RE: LFPCN41229

Subject: LFPCN41229- Alternative Assembly Location Approval

Product/Process Change Notice (PCN)

Product Qualification Report

1.2. Marking change

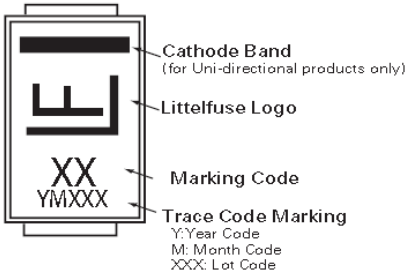
Will change the trace code marking from YMXXX to YM6XX and number 6 is the outsource code.

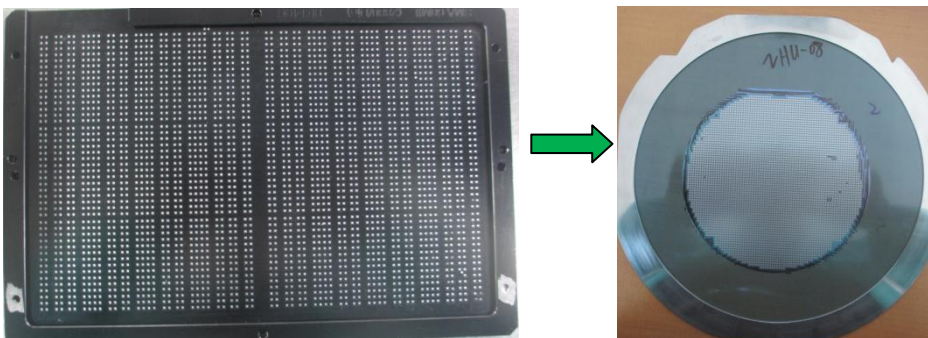
2.1. The method loading method will be changed to adapt outsource process, so the dicing and soldering process is different

2.2. The outside plating in outsource is racking plating.

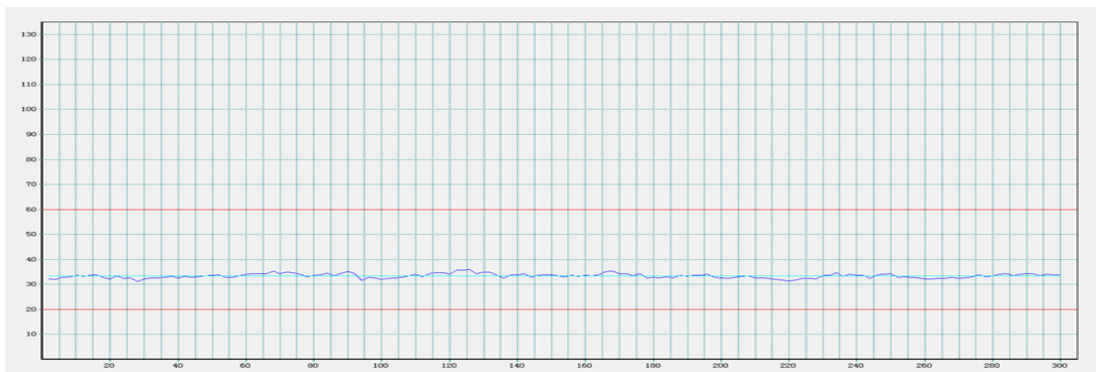
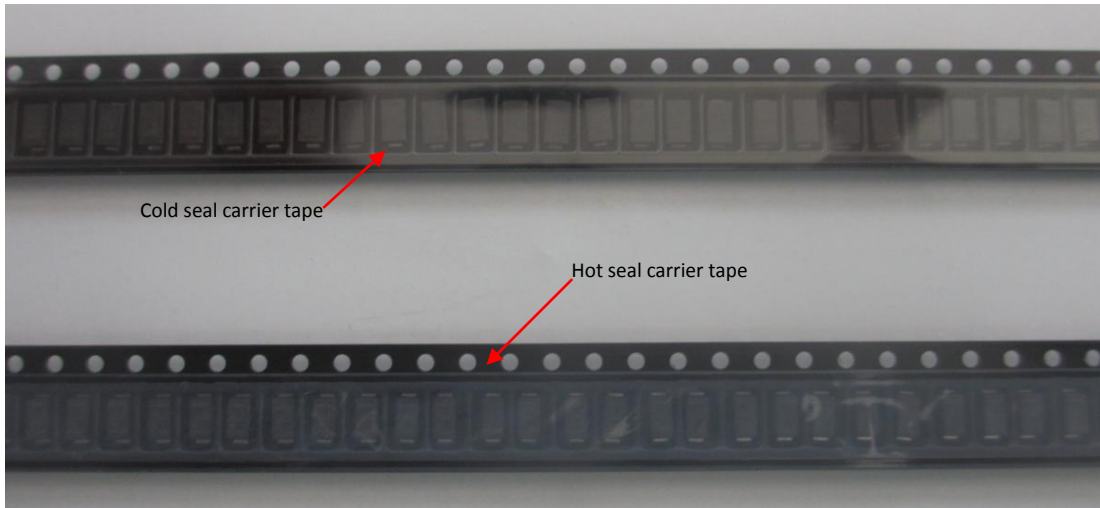
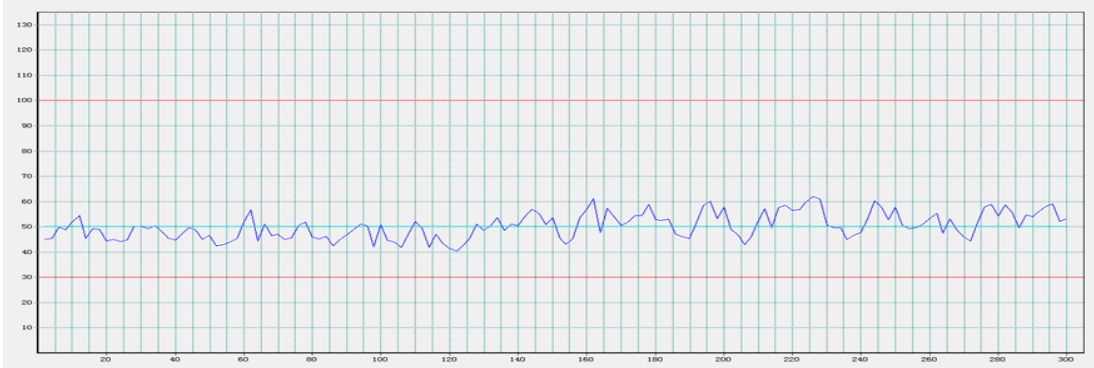
3.1. The carrier pull force also change from 20~60g to 30~100g because Change SMA/DO-214AC series carrier tape to hot seal carrier tape.

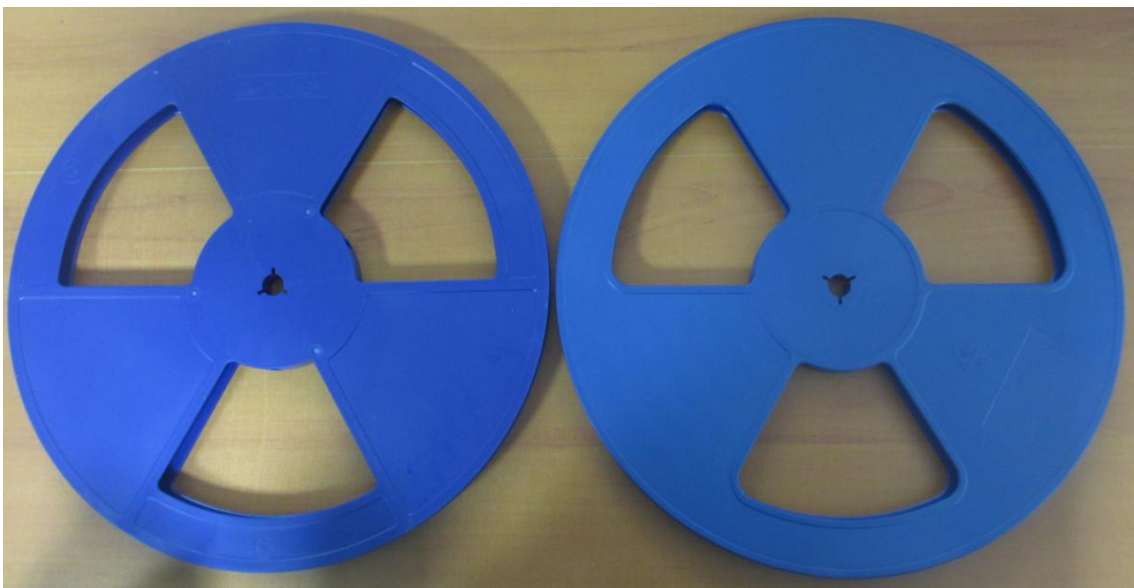
3.2. The blue plastic tape will change to outsource tape and the dimension will not change.

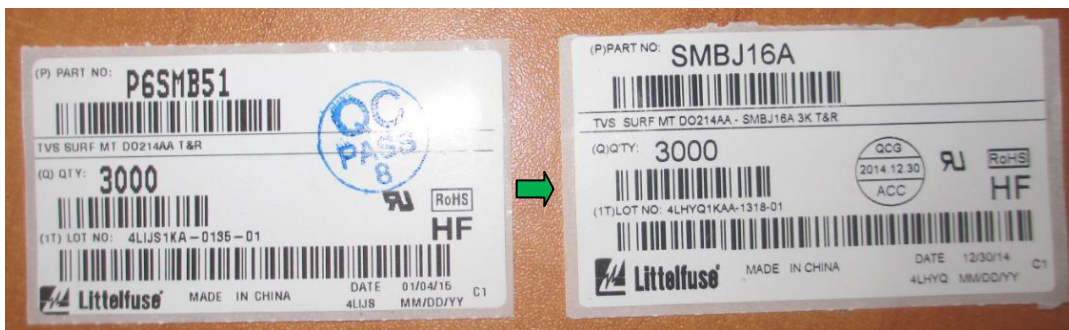
3.3. The label on internal pizza box is changed and print the QC signet on the label.
